# Access Compliance Report

## Public Rights-of-Way

| Intersection ID: 44158                  | Main Street: MEADOW_KNOLL_DR | Cross Street: FEATHER_BEND_CT           | Location: SW           |
| ADA ID: 7CBE8FAB2848                    | Ramp Type: PerpDiag          | Initial Pass/Fail: Fail                 | Overall Compliance: No |

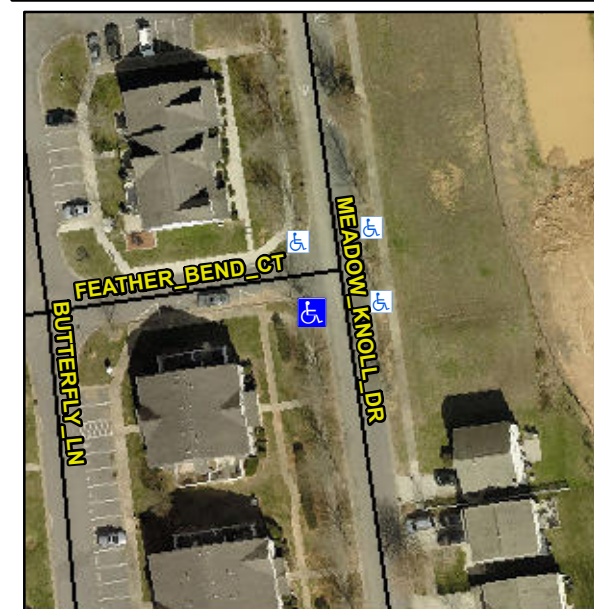
| Severity Score: 22.5                    |                              |   |                        |

**Not Found, R304.5.1, R304.2.2, R304.5.3**

| Compliance | Description           | Data | Compliance | Description                 | Data |
|------------|-----------------------|------|------------|-----------------------------|------|
| N/A        | Ramp Length (in)      | 87.5 | No         | Ramp Slope (%)              | 10.7 |
| No         | Ramp Width (in)       | 44.0 | No         | Ramp XSlope (%)             | 3.6  |

**Remove & Replace Curb Ramp With Two New Directional Ramps or Equivalent.**
